PLAN-006118

Proposal: Rear extension and loft conversion.

Site: Redcot, Climping Street, Climping, BN17 5RQ.

CM/7/14/HH

Southern Water MapGuide Browser

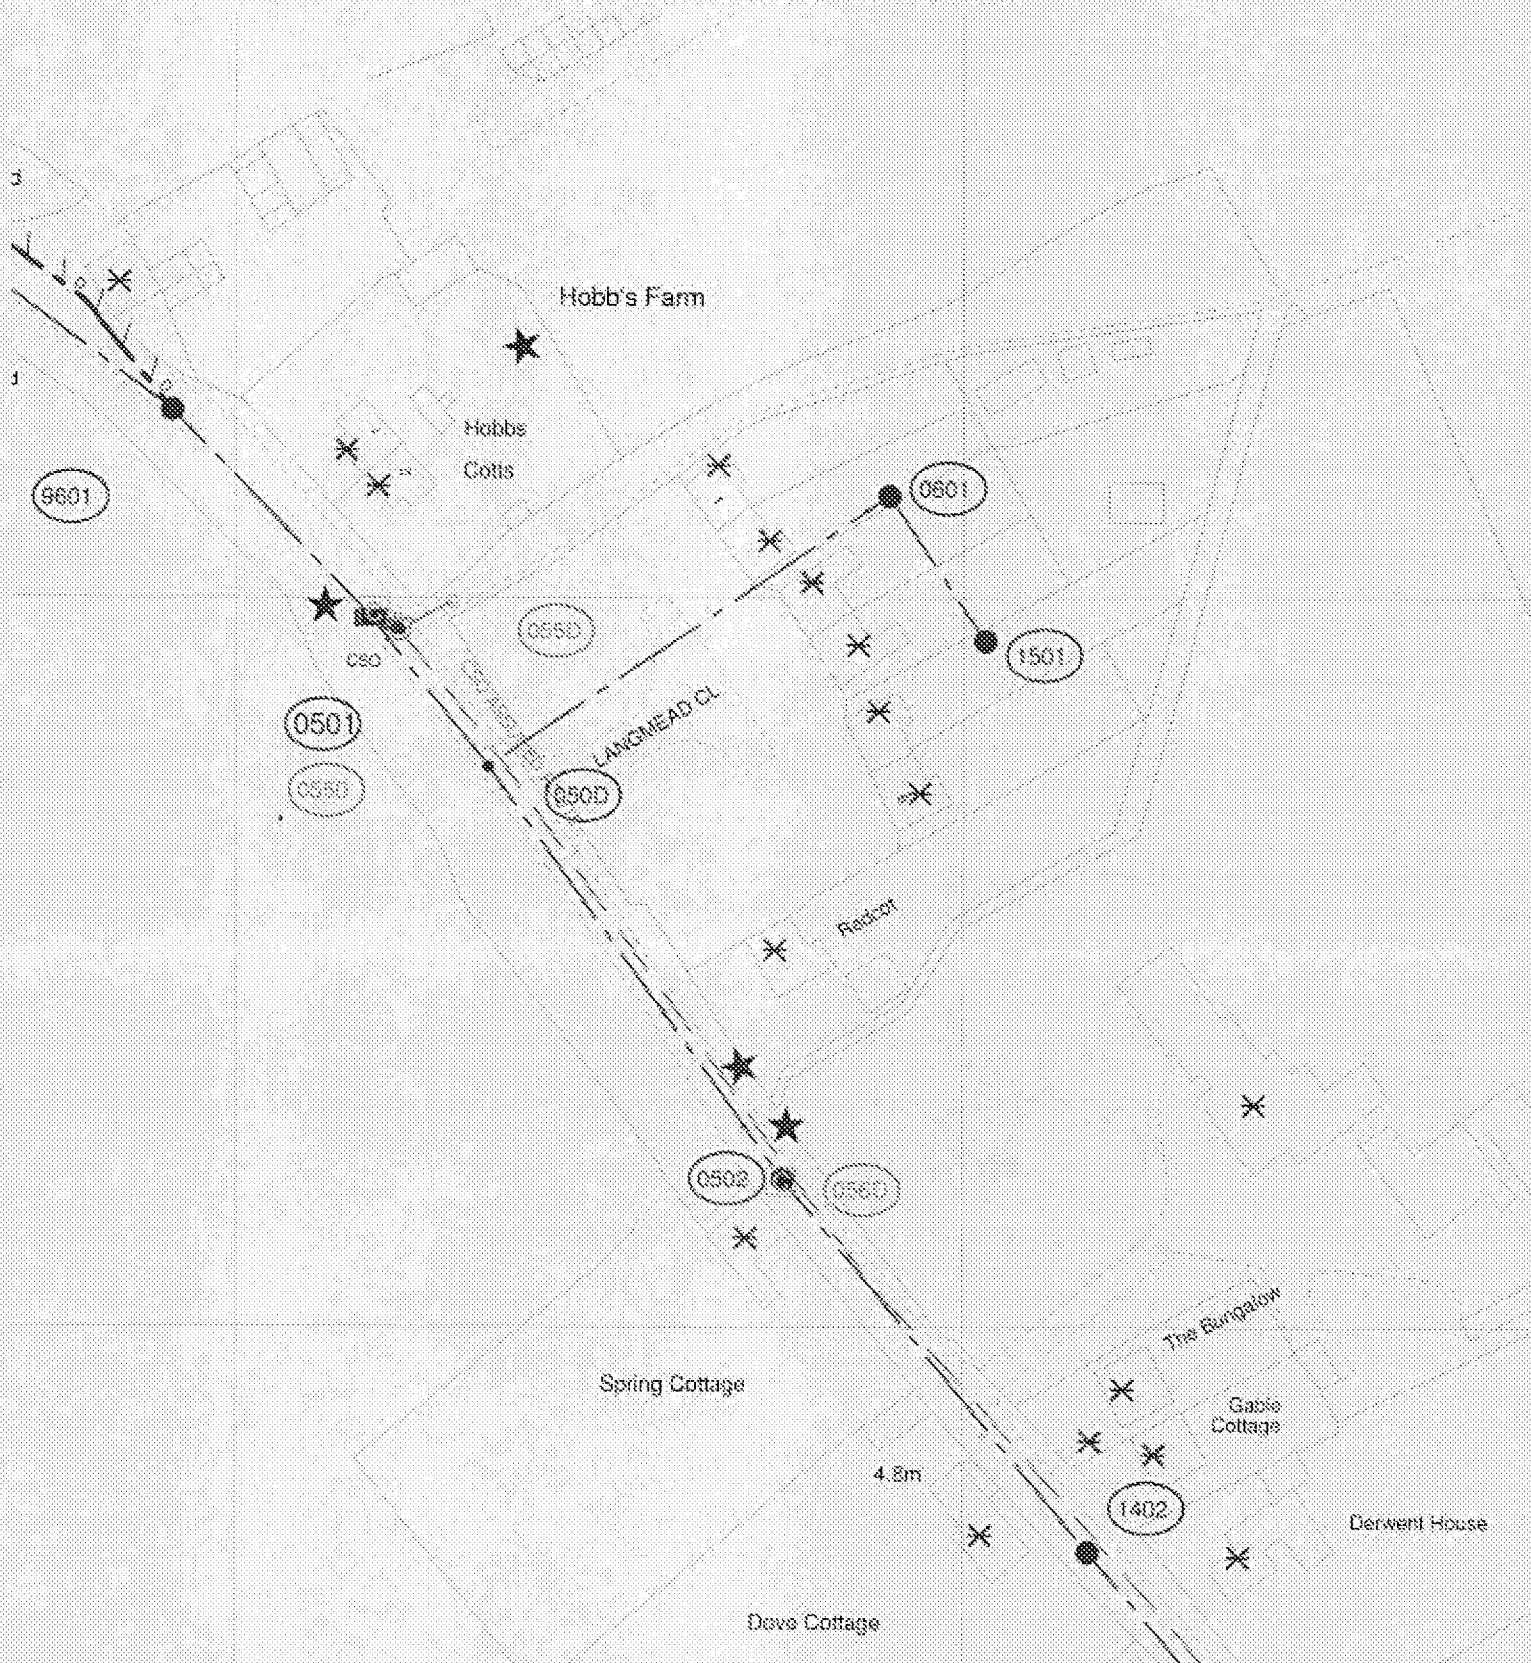
Due to changes in legislation that came in to force on 1st October 2011 regarding the future ownership of sewers it is possible that a sewer now deemed to be public could be crossing the above property. Therefore, should any sewer be found during construction works, an investigation of the sewer will be required to ascertain its condition, the number of properties served, and potential means of access before any further works commence on site.

Developer should look to protect the public sewerage system from inundation and infiltration, which contribute to flooding in unfavourable conditions.

The applicant is advised to discuss the matter further with Southern Water, Southern House, Sparrowgrove, Otterbourne, Hampshire SO21 2SW (Tel: 0330 303 0119) or www.southernwater.co.uk.
